Service Bulletin

No. : MZ09-022 **Date:** April 1, 2009

Model: SR4002, SR5002, SR4003, SR5003, SR6003

Subject: Improvement of GND screws contact.

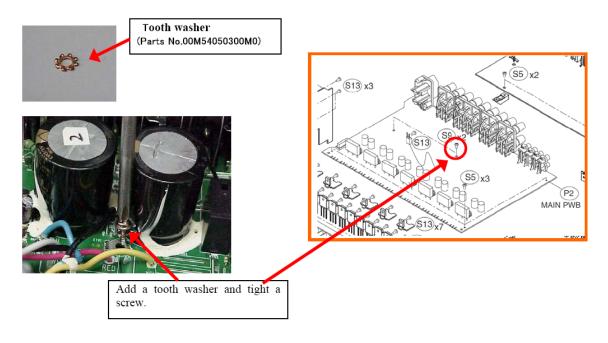
Symptom: The unit may intermittently go into protection (Fast blinking Stand by LED). No problems are found in the output circuitry and heat is not an issue. The ground point screw on a Main board can loosen during transportation, handling etc., and the contact to ground may become intermittent causing a protect situation.

Solution: Add a toothed washer between the ground point screw and PCB land located on a Main board (see diagram below) and then tighten the screw.
